RE: Prairie Point West (fka Kings Point Northwest) ISP 6th Submission Review Response to Comments

PRAIRIE POINT (FKA KINGS POINT NORTH)
WEST INFRASTRUCTURE SITE PLAN

PRAIRIE POINT WEST ISP	DATE: 02/17/2023
WEST INFRASTRUCTURE SITE PLAN COVER SHEET	JOB NO: 12187.61
SCALE AS NOTED	
1 of 53

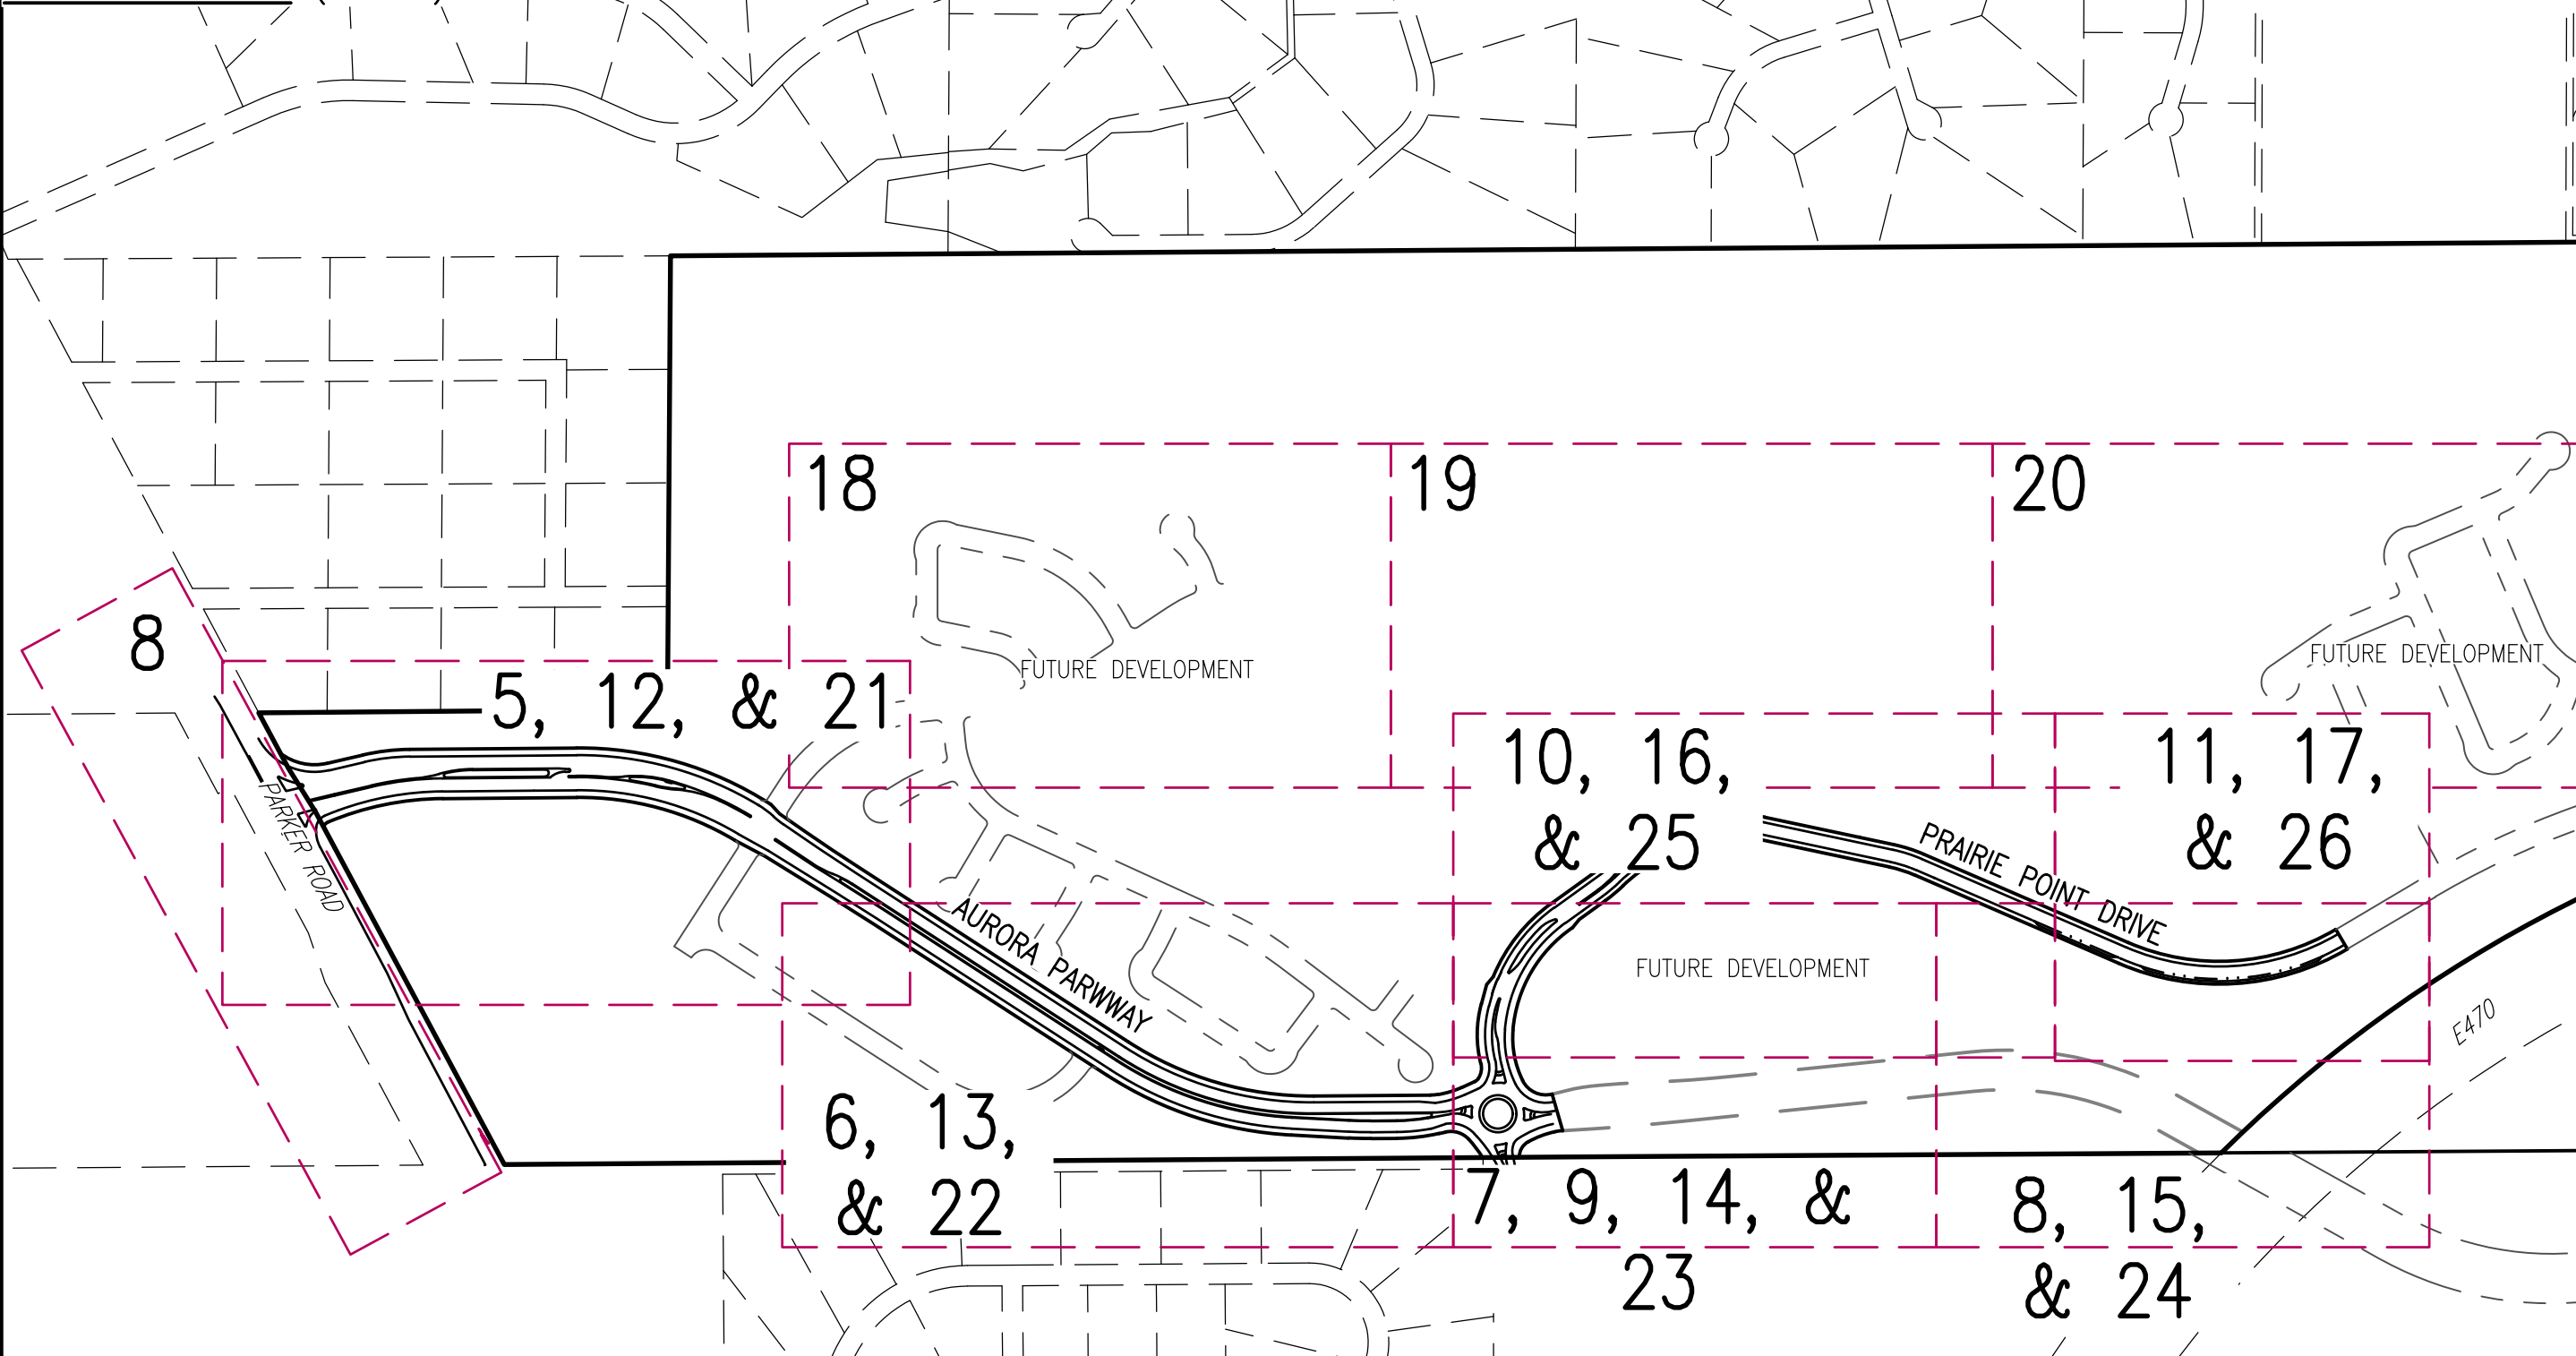
- a. The site plan will not be approved by Public Works until the preliminary drainage letter/report is approved.

The site plan will not be approved by public works until the preliminary drainage letter/report is approved

As of 3/2/23 PDR not approved

RESPONSE: THE PDR WAS RESUBMITTED ON 3/31/2023.

THE PDR WAS RESUBMITTED ON 3/31/2023

DATE: 02/17/2023
JOB NO: 12187.61
SCALE
HORIZONTAL
1" = 40'
7 of 53

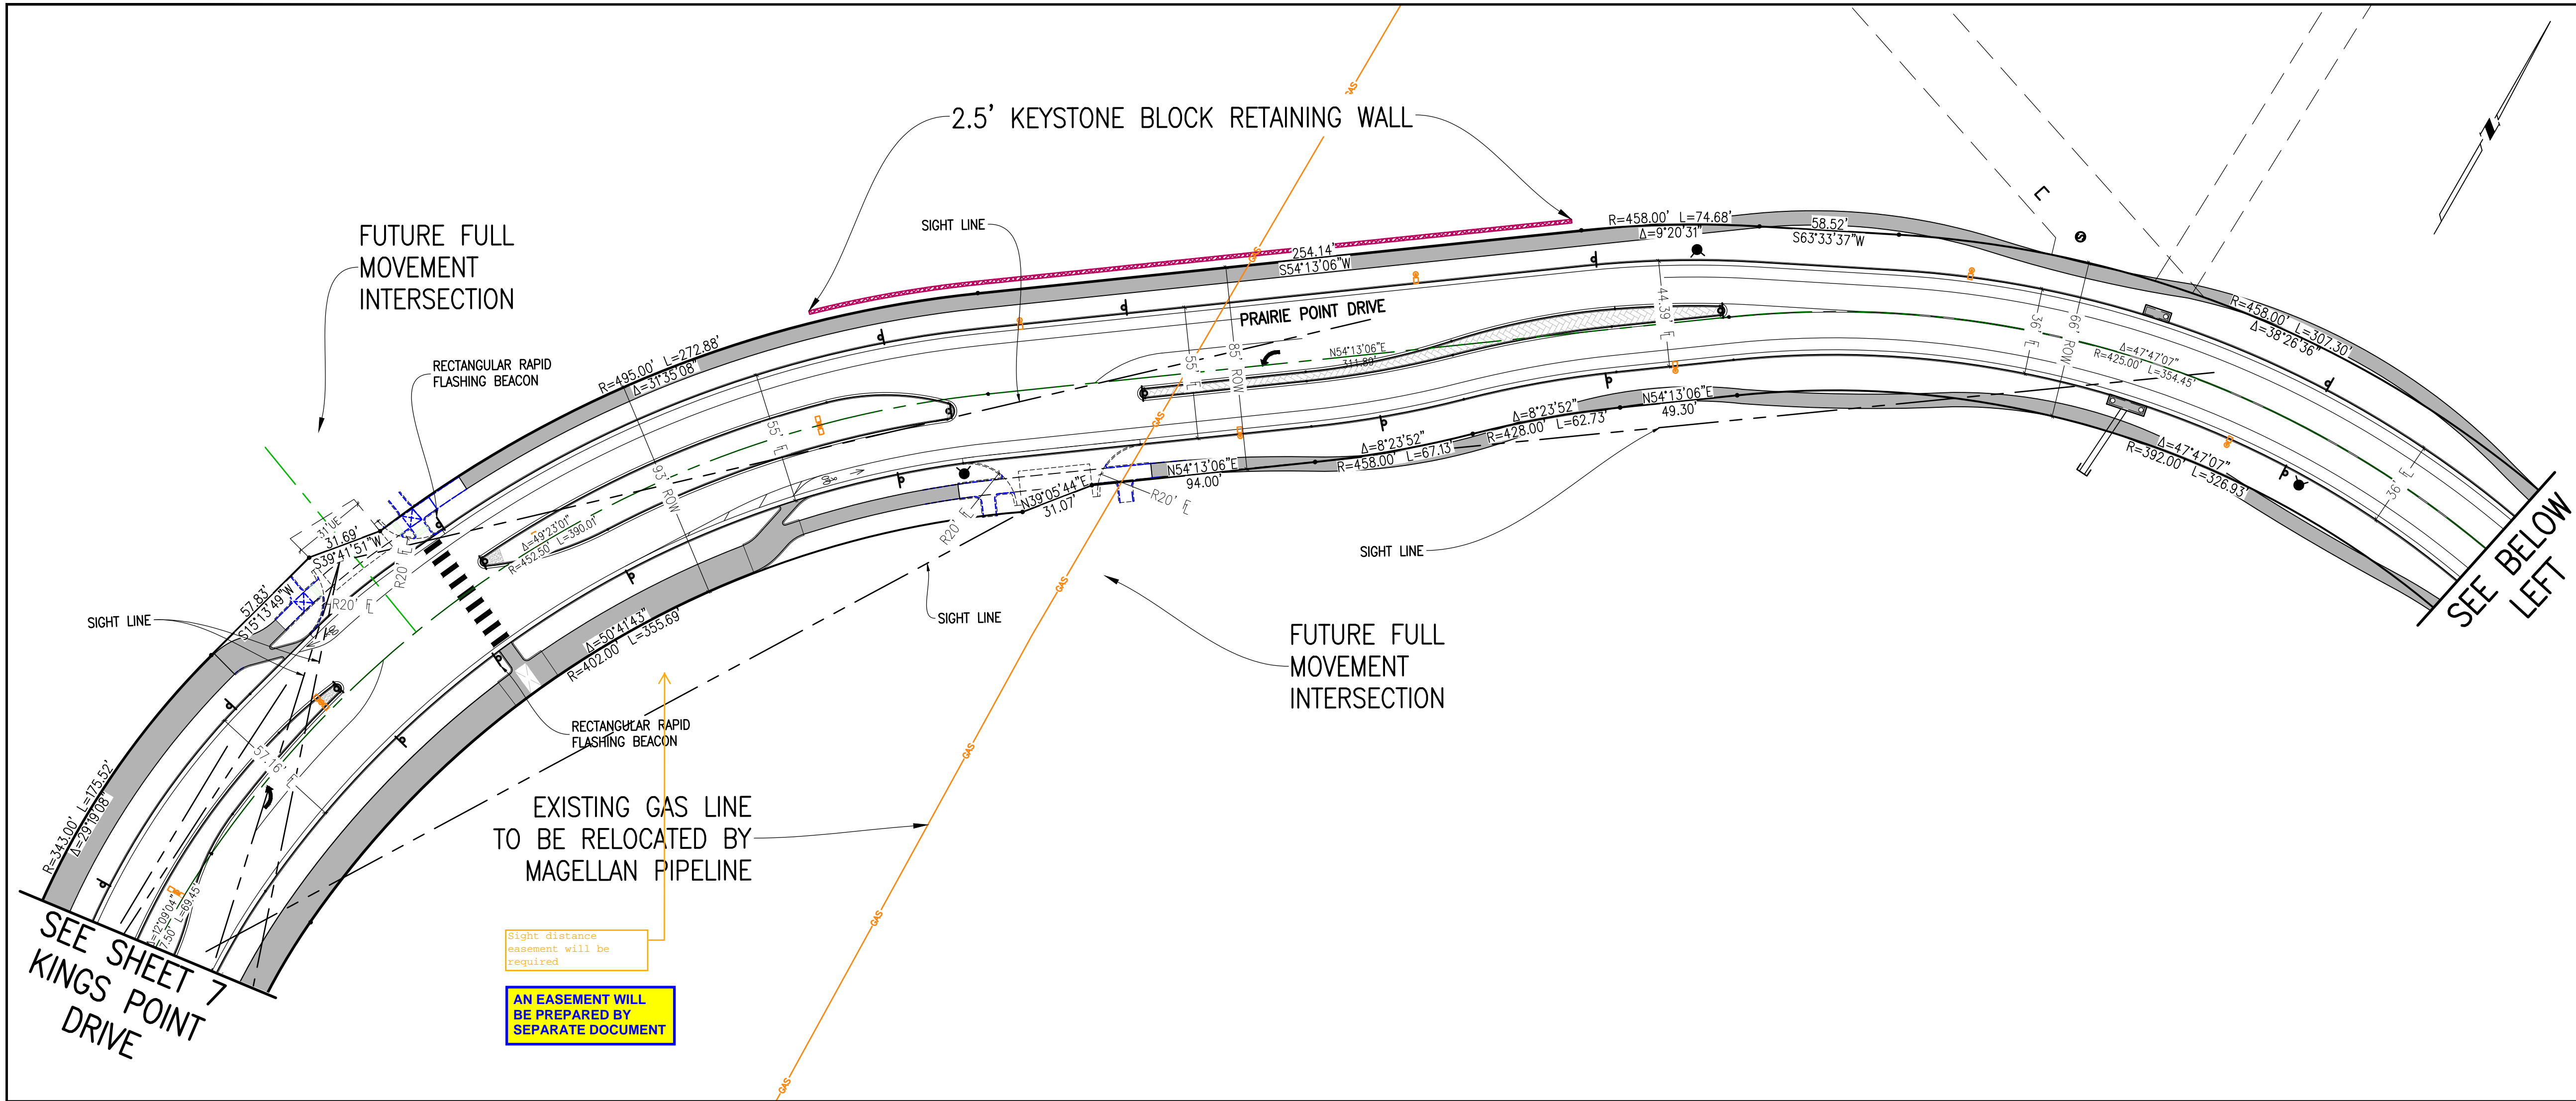
- a. No thru movement arrow for interim.

- b. Adjust hatching and dashed line.

- c. Add Yield lines.
RESPONSE: THE STRIPING HAS BEEN REVISED AS REQUESTED.
 - d. Extend solid line striping.
RESPONSE: THE STRIPING HAS BEEN REVISED AS REQUESTED.

- e. Provide lane designation sign for each lane allowed movement.
RESPONSE: THE REQUESTED SIGN HAS BEEN ADDED.
[ISP Page 10]
 - f. Sight distance easement will be required.

RESPONSE: THE REQUESTED SIGN HAS BEEN ADDED.

RESPONSE: THE STRIPING HAS BEEN REVISED AS REQUESTED.
